# PINTLE NOZZLES

WORKSHOP: EP  
05.1987

CHANGES TO THE TESTERS FOR IN-LINE  
PUMPS

Workshop: EP  
07.1987

1 420 100 001 (Illustration, Item 3)

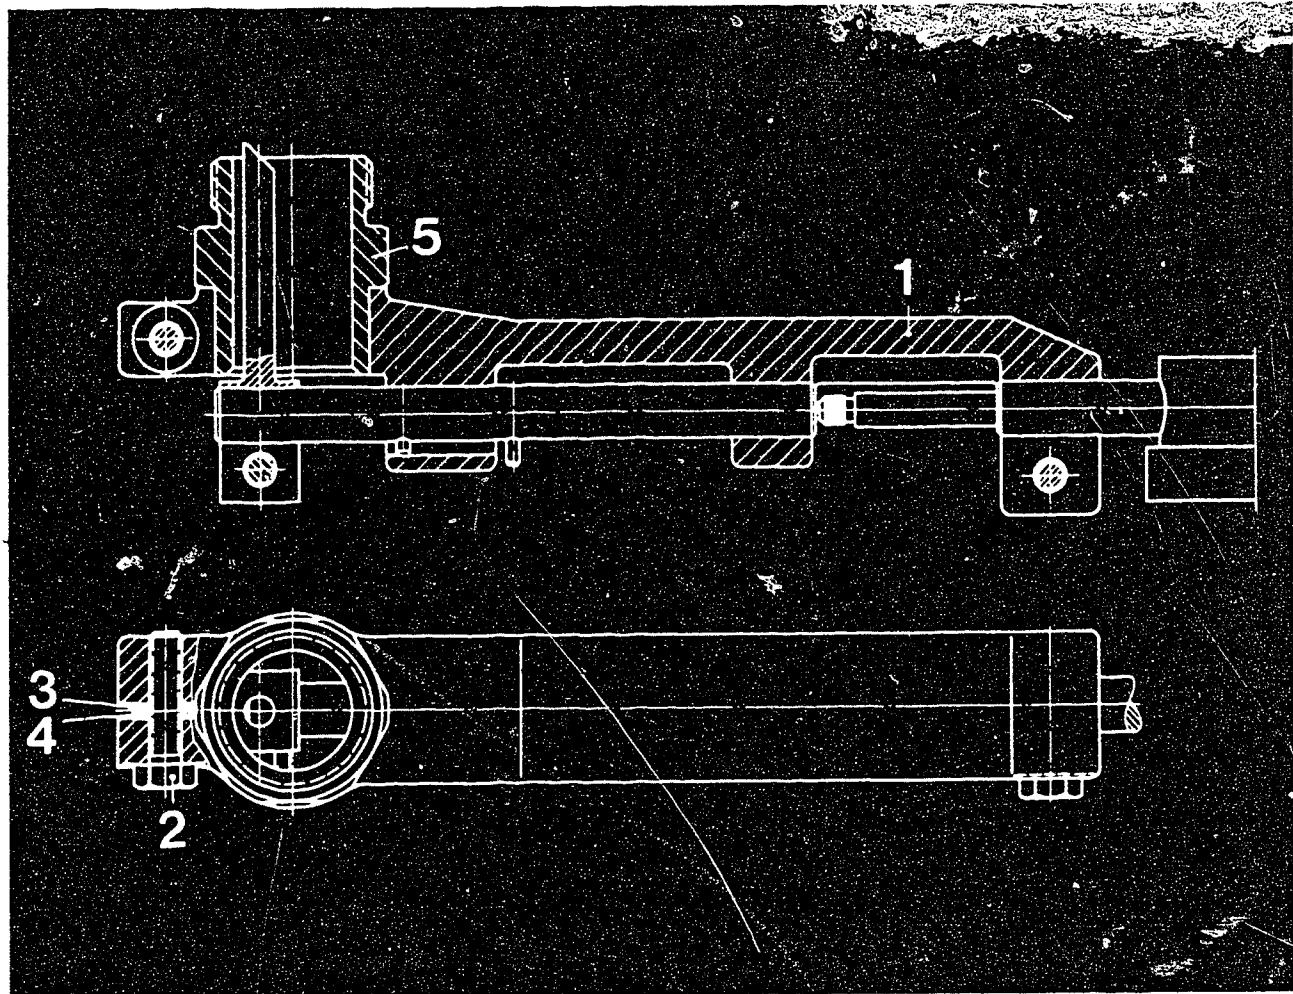
Remedy: installation of 2 shims

1 420 100 002 (Illustration, Item 4)

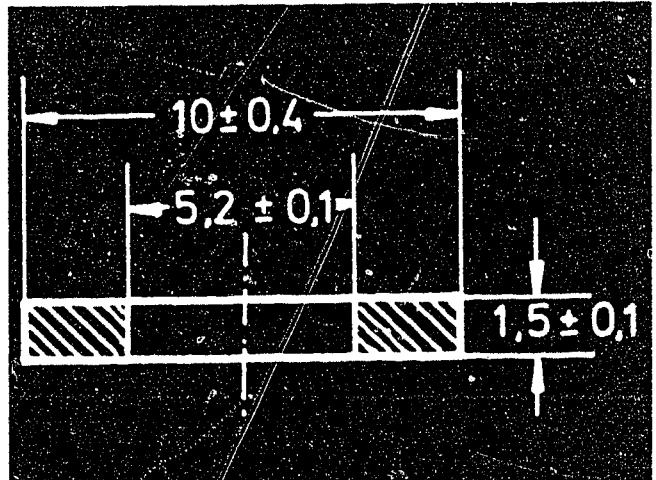
If the shims listed are not available, they may be replaced by one user-manufactured shim (see illustration).

## 2. Alteration of the adjusting shims

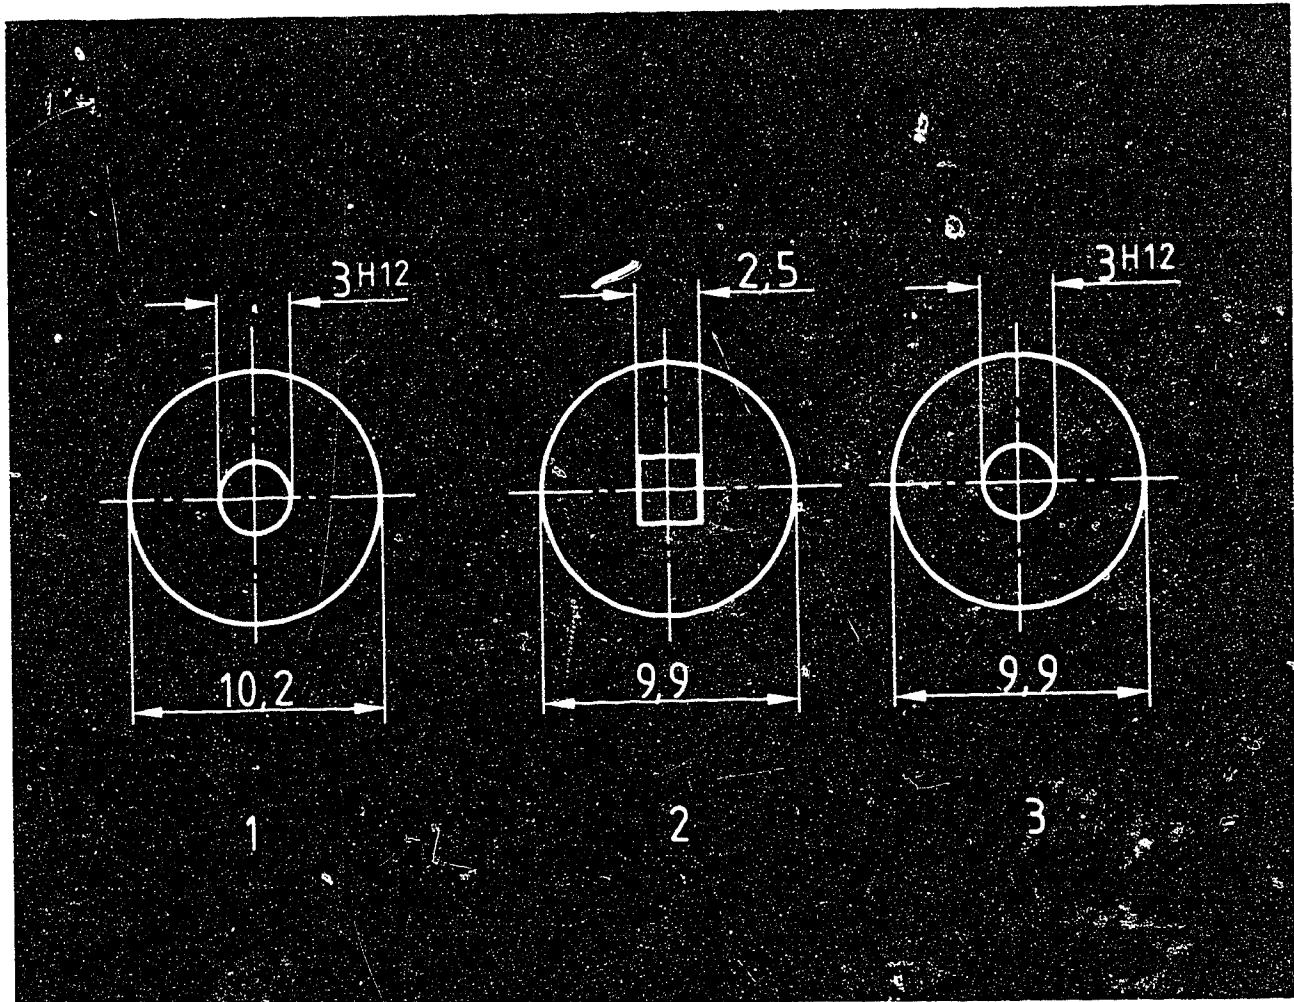
The spring guide has been improved in the KDEL, KBEL,  
KBELZ nozzle-holder assemblies size P and KDEL, KBE and  
KBEL size S with 21 mm shank diameter (standard switch).

As a result of a change to the diameter of the spring guide  
from 10.4 mm to 10.2 mm, the diameter of the adjusting  
shims is also changed from 10.2 mm to 9.9 mm.

3 = Modified new adjusting shim 2 430 101 170  
to .. 219

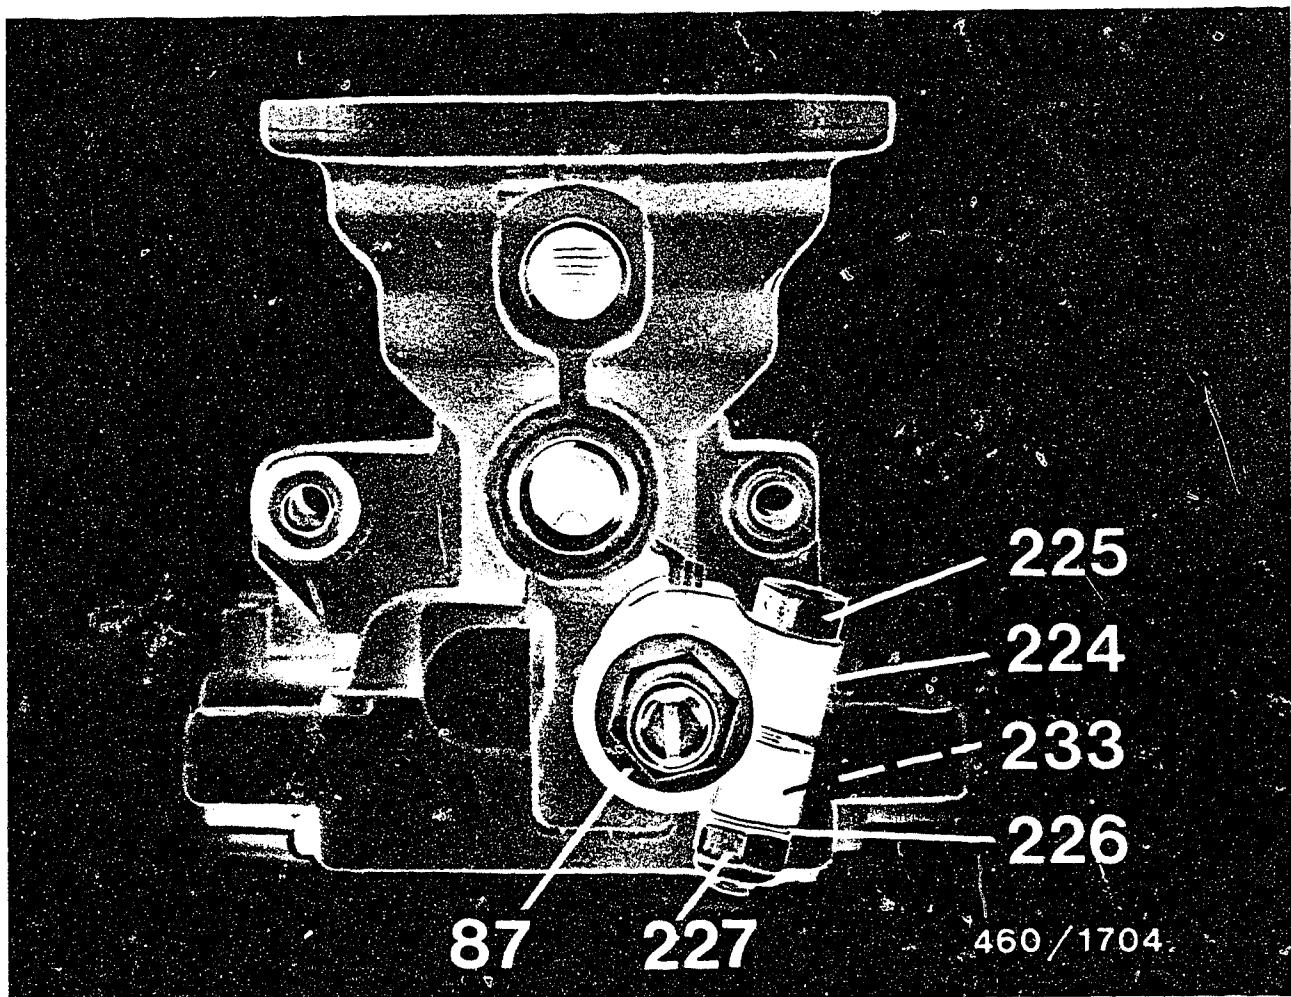
As of FD 742 (2.87), the above-mentioned VE-EP has been modified  
while retaining the part number 0 460 406 047.

The VE-EPs up to FD 741 (1.87) and as of FD 742 (2.87) are  
not interchangeable.

In addition to the FD, the external distinguishing feature of the  
new VE-EP is the lack of full-load-adjustment device (see illustration).

Illustration a = Spacer with identification groove

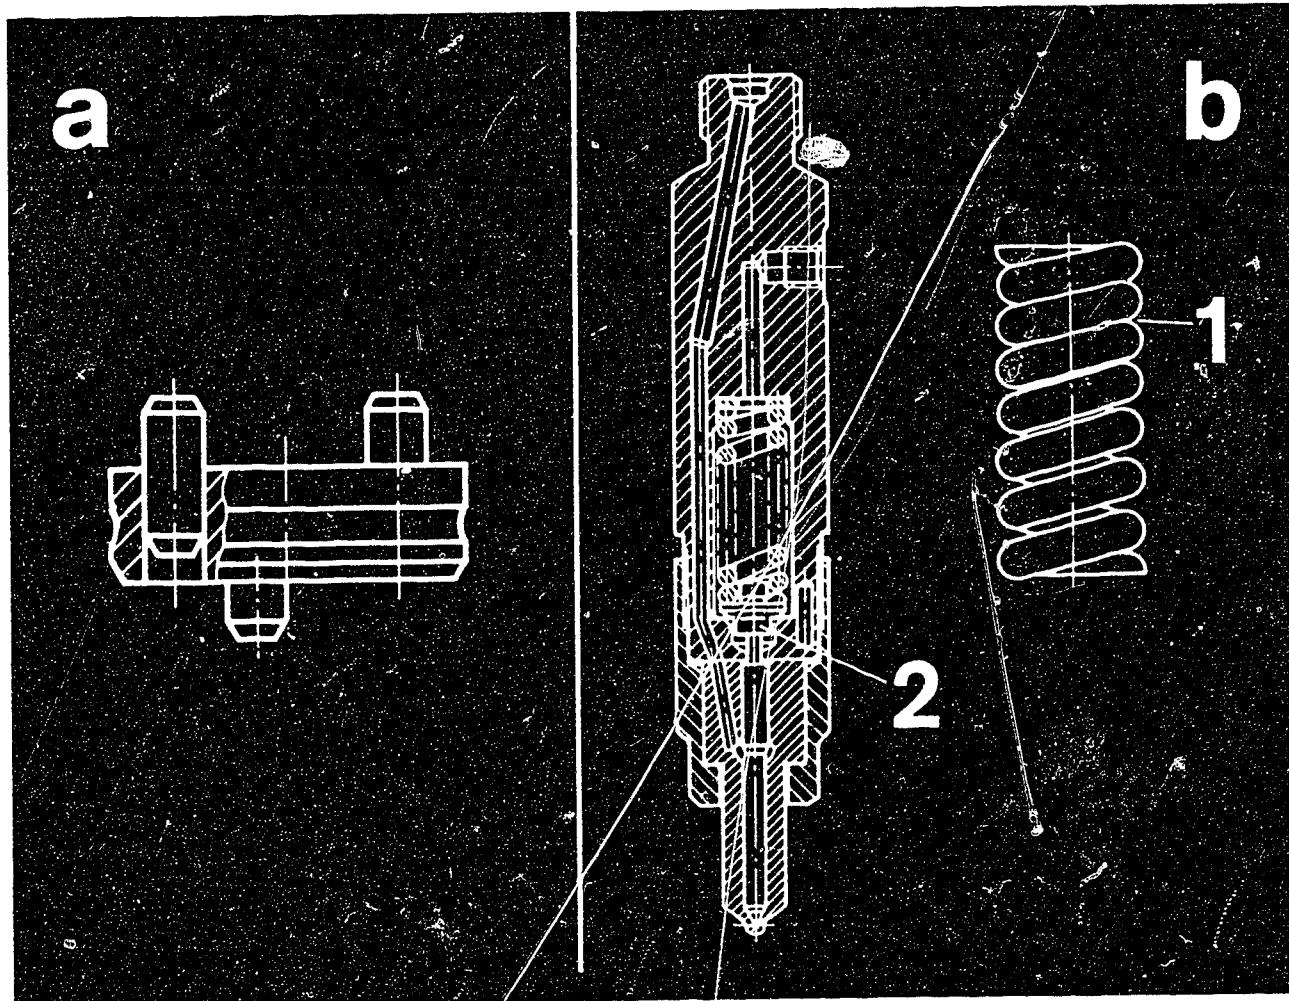
In order to avoid further failures, this nozzle has been modified. It now has the marking "87-" on its shaft.

The associated nozzle-holder assembly 0 430 133 997 (KDEL 97 P3) has been modified in the following way.

Nozzles and nozzle-and-holder assemblies which correspond to the modified version must be exchanged only as a set on any one individual engine. The nozzles and assemblies must not be mixed; i.e., when there is a complaint concerning a nozzle-and-holder assembly, all of the nozzle-and-holder assemblies must be converted to the latest state of the art.

DISTRIBUTOR-TYPE FUEL-INJECTION PUMP VE..F..  
R 162-2 AND R 162-4  
O 460 4..  
Modification of the housing cover

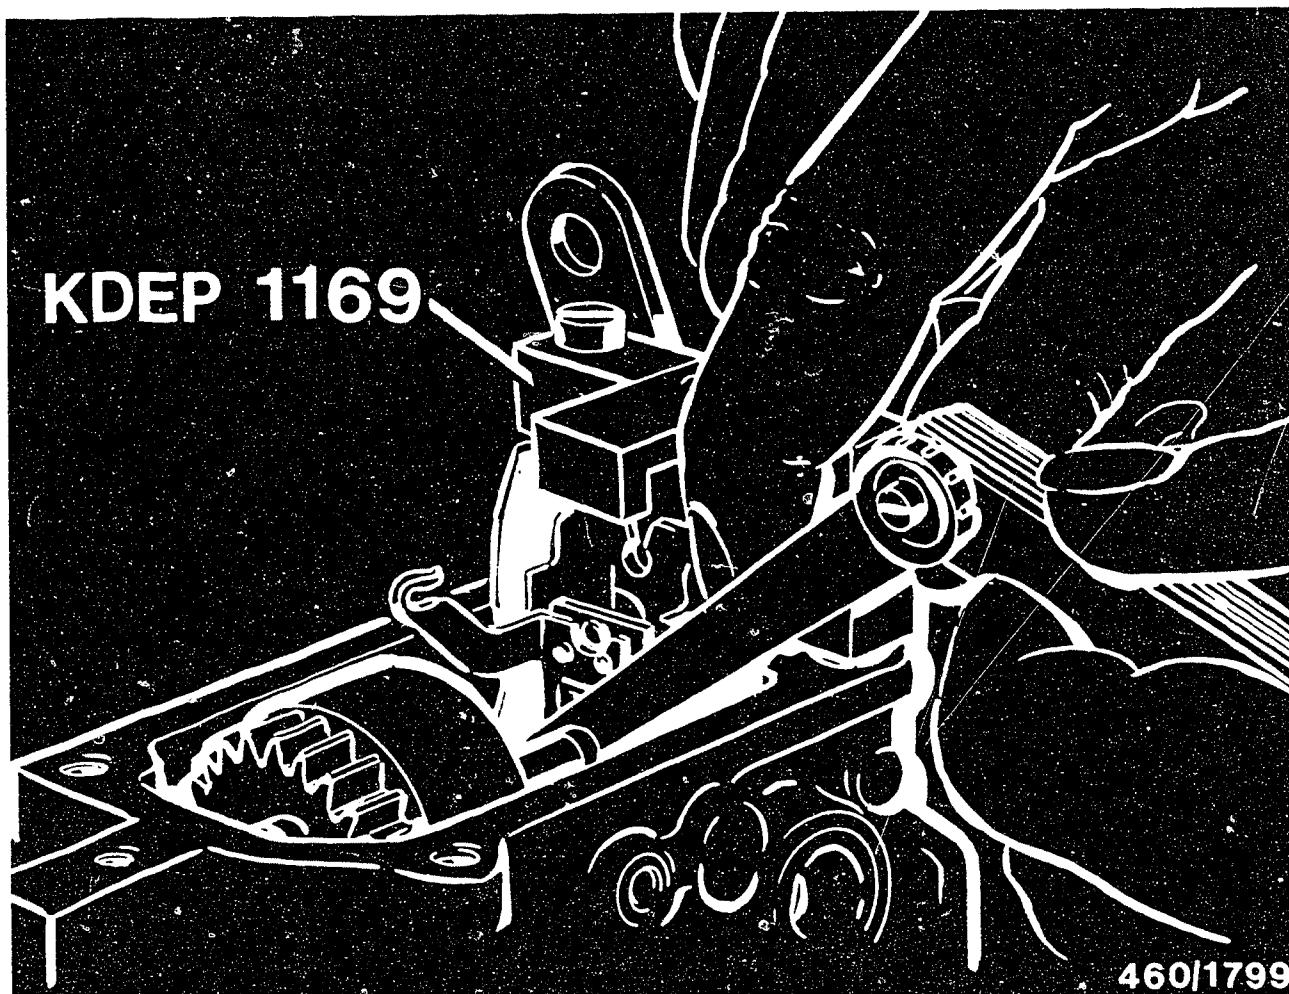
In the case of the above-mentioned injection pumps, the previous version with "fulcrum-lever stop in the distributor-type fuel-injection-pump housing" is being modified into a "fulcrum-lever stop in the housing cover" version. The version is characterized externally by a depression in the housing cover (arrow).

VE 6/10F 2300 R206 - 0 460 406 047 (BMW 324 d)

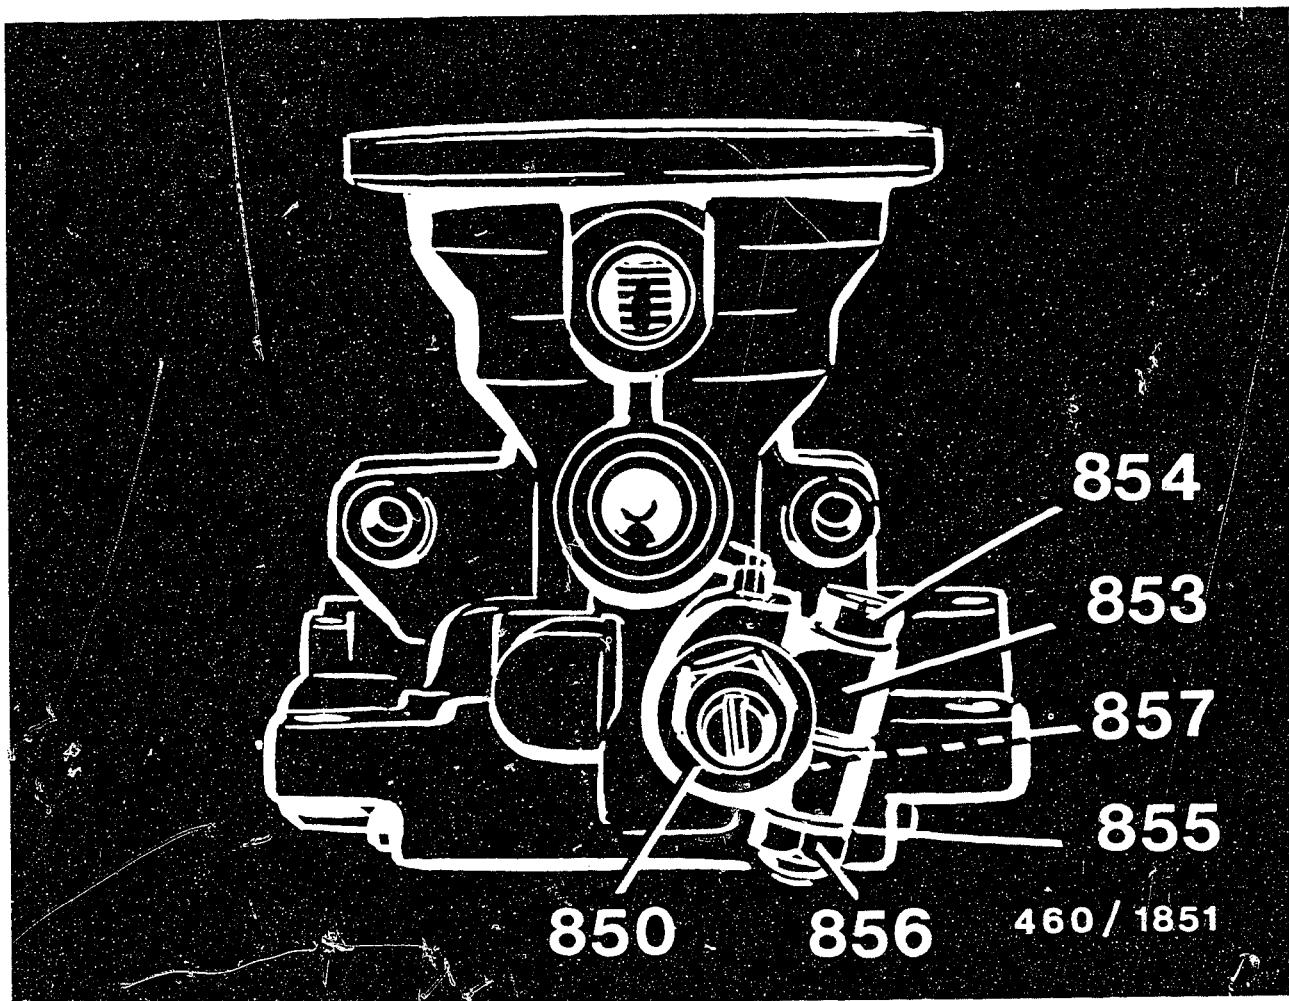
As of date of manufacture FD 742 (2.87) the above-mentioned distributor-type fuel-injection pump was modified whilst retaining the part no. 0 460 406 047. Distributor-type fuel-injection pumps up to FD 741 (1.87) and as of FD 742 (2.87) are not interchangeable. Apart from the date of manufacture, the ext. charac. feature of the new dist.-type fuel-inj. pumps is that there is no ext. charac. full-load adjuster (see illustr.).
